Mr. J. M. Martin
Regional Administrator
U. S. Nuclear Regulatory Commission
Office of Inspection and Enforcement
Region V
1450 Maria Lane, Suite 210
Walnut Creek, California 94596-5368

July 20, 1983

COMMENTS ON PROPOSED LETTER DATED
JULY 20, 1983, FROM JOHN MERTENS TO
J. B. MARTIN, USNRC

III. RESPONSE TO CONCERNS STATED IN PROPOSED LETTER
DATED JULY 20, 1983, FROM JOHN MERTENS
TO J.-B. MARTIN, USNRC

FIGURE 1

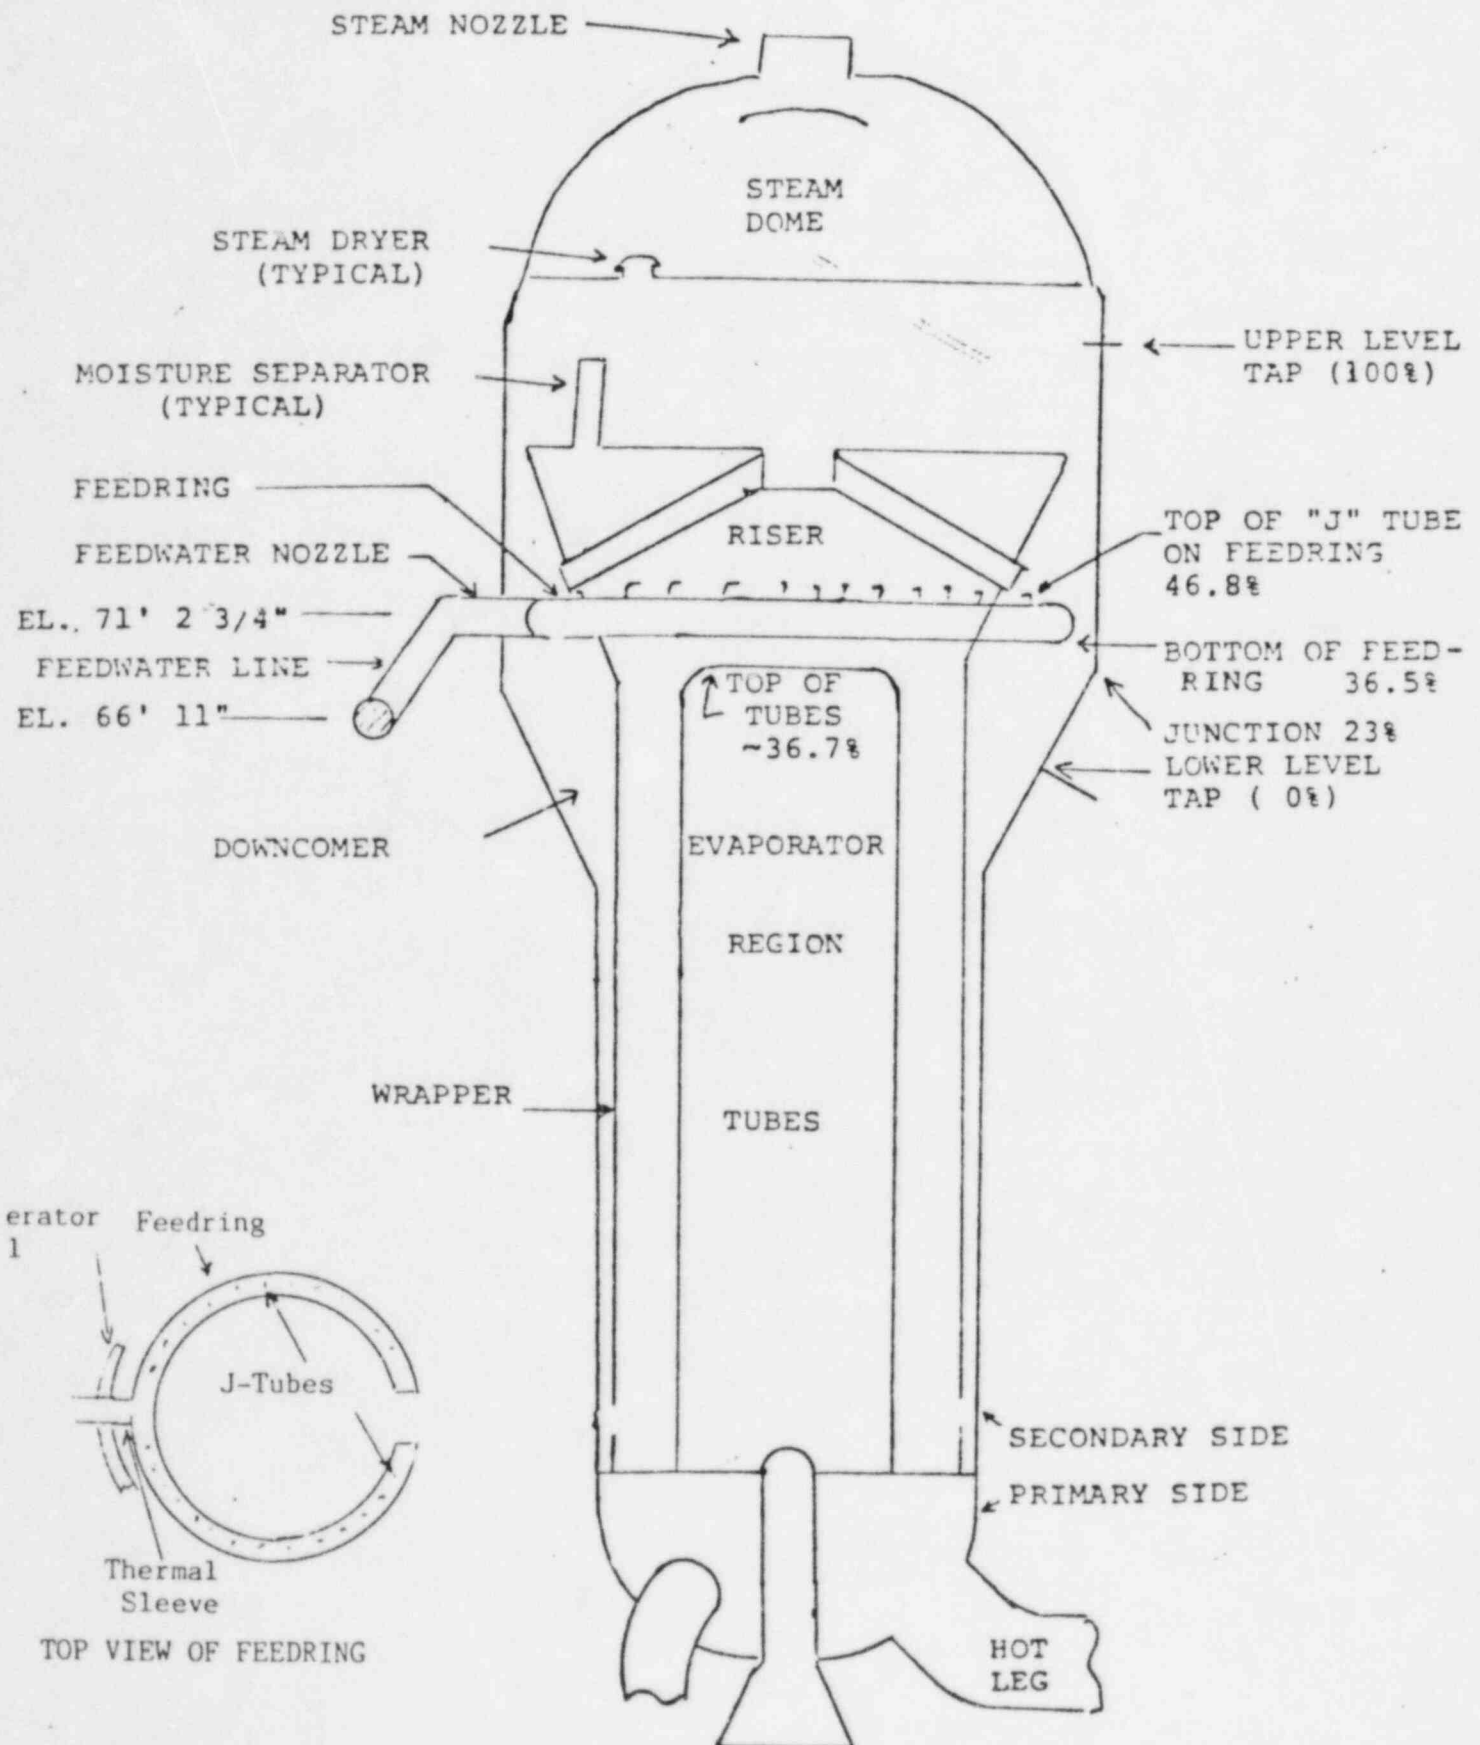
The operational history of the main feedwater piping begins with the NRC's review of the piping design criteria. As stated in the Final Safety Analysis, paragraph 10.4.7.1.D, the system is not designed for abnormal hydraulic loads since design and operating considerations preclude their occurrence. The NRC requested that a special test be added to the startup program to verify the FSA design criteria in that unacceptable waterhammer would not occur as a result of uncovering and draining the feedring (refer to Figure 1 for a sketch of the steam generator internals). In March 1981, when this test was performed on steam generator E088 and feedline FW189, a thud was heard and attributed to a check valve slamming open. No damage to piping or supports was noted during a subsequent visual inspection of the piping. Later, in July 1981, during a scheduled generator internals inspection, the feedring was found to be damaged. The cause of failure was attributed to the dynamic differential pressure forces applied to the feedring due to rapid injection of auxiliary feedwater into the drained feedring. The design was modified to increase the time required to drain the feedring, to reduce the magnitude of the differential pressure dynamic loading, and improve the capability to withstand compressive loading. A supplemental feedring integrity test with less severe conditions was scheduled for later in the startup program to verify these modifications. This test was conducted in June 1982. No indications of waterhammer, such as noise or vibration, were observed during the test. A subsequent visual inspection of the feedring, the feedwater piping, and piping supports showed no damage.

FIGURE 2

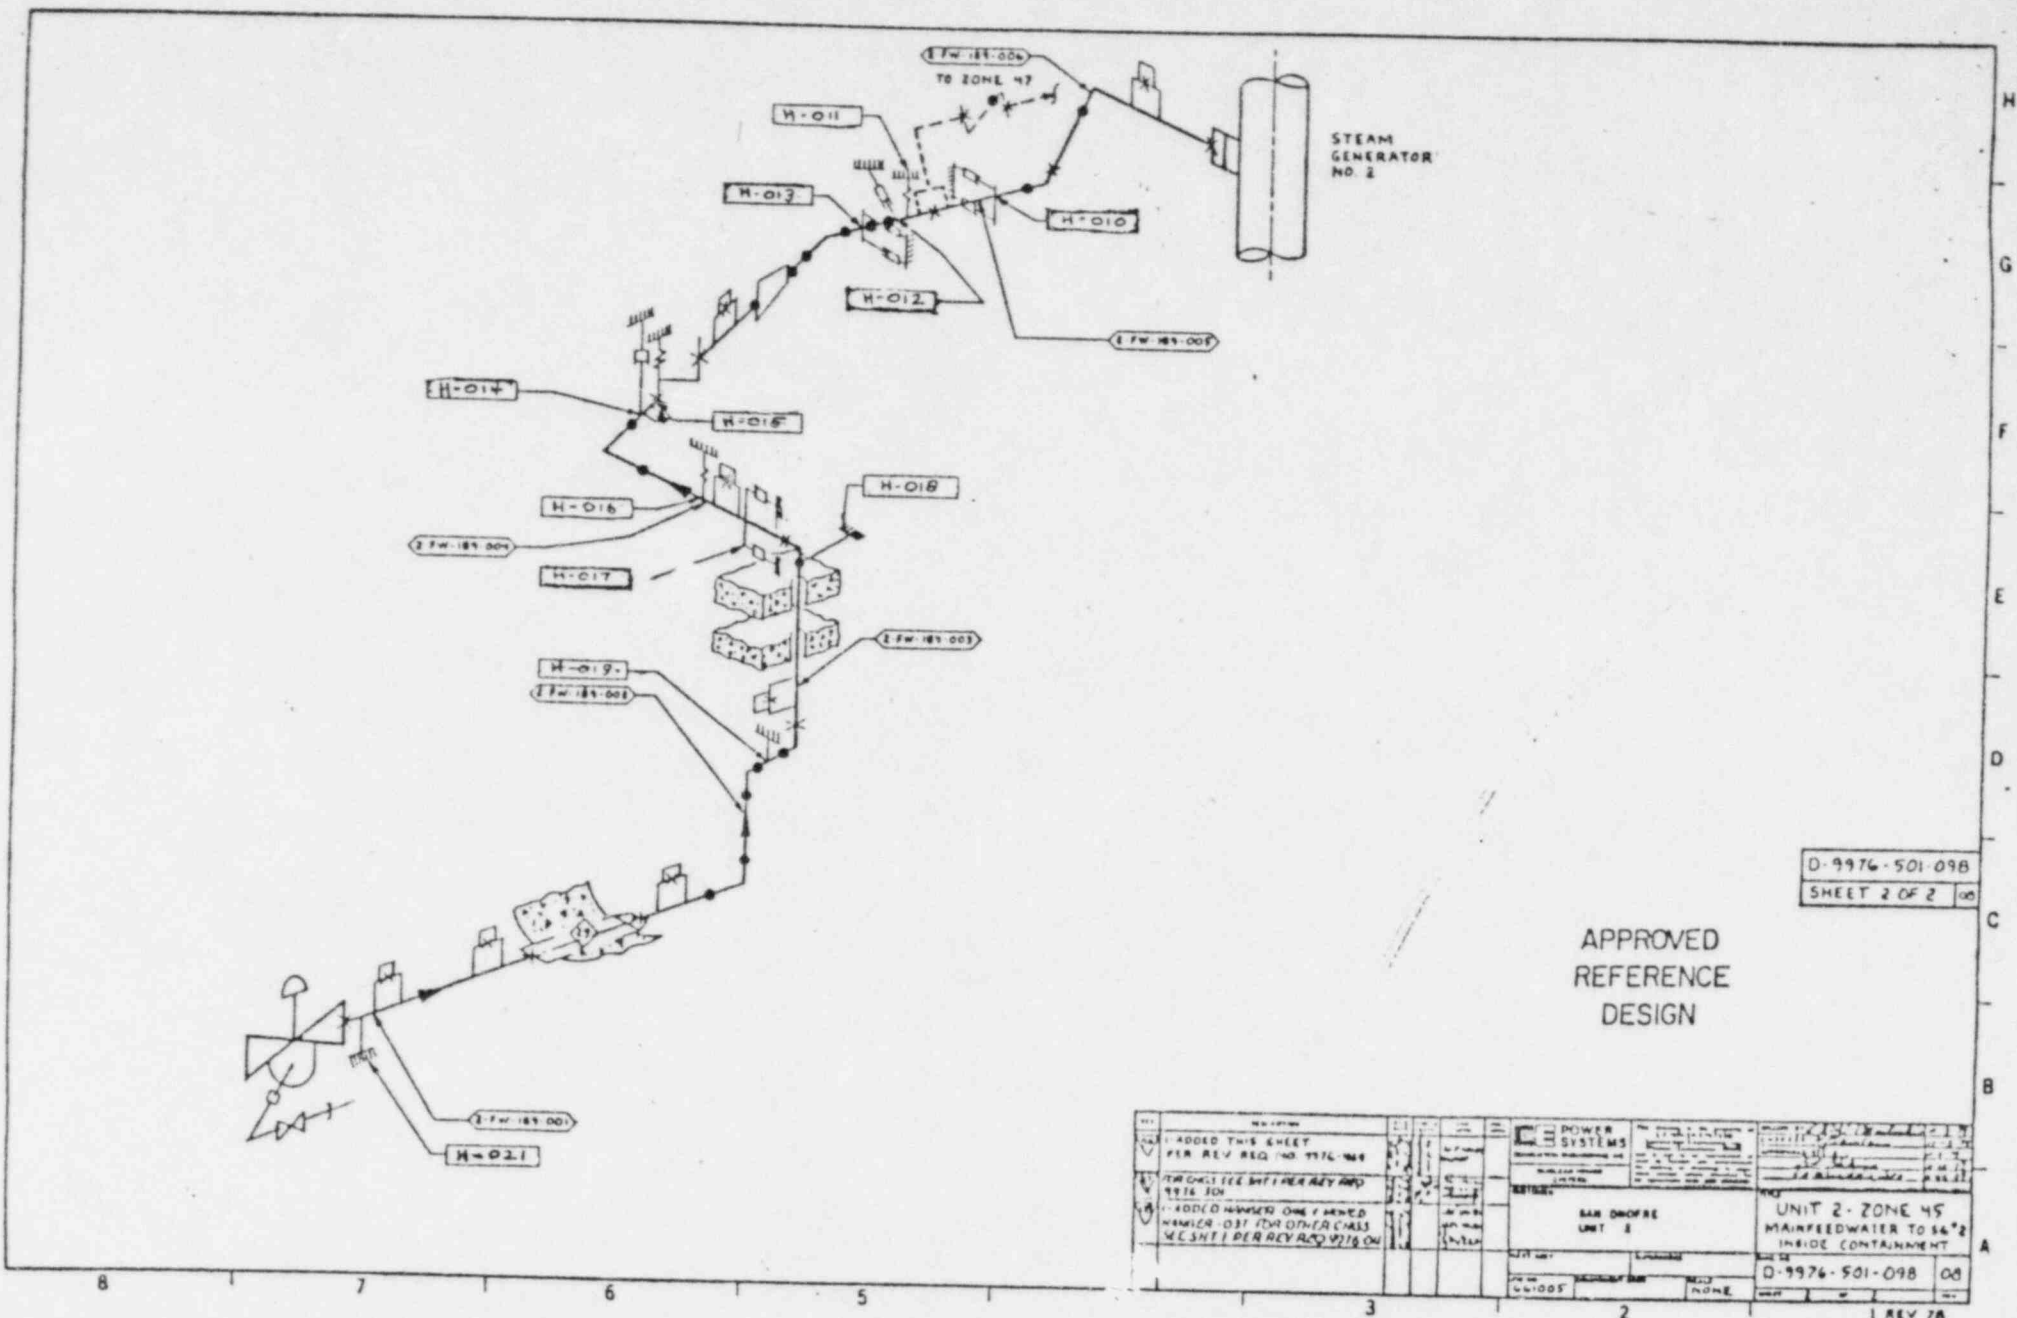
On December 9, 1982, while performing the feedwater piping thermal expansion test at the 50% power plateau, a mechanical snubber at location S2-189-H013 (see Figure 2) was found damaged. The initial engineering investigation (Attachment 4) concluded that the remaining mechanical snubbers, five additional for a total of six in question, at locations S2-189-H013, S2-189-H010, and S2-189-H017 were probably also damaged. Eventually, the original damaged snubber and four others were replaced. The sixth, on support S2-189-H010, was manually stroked with satisfactory results and was not replaced.
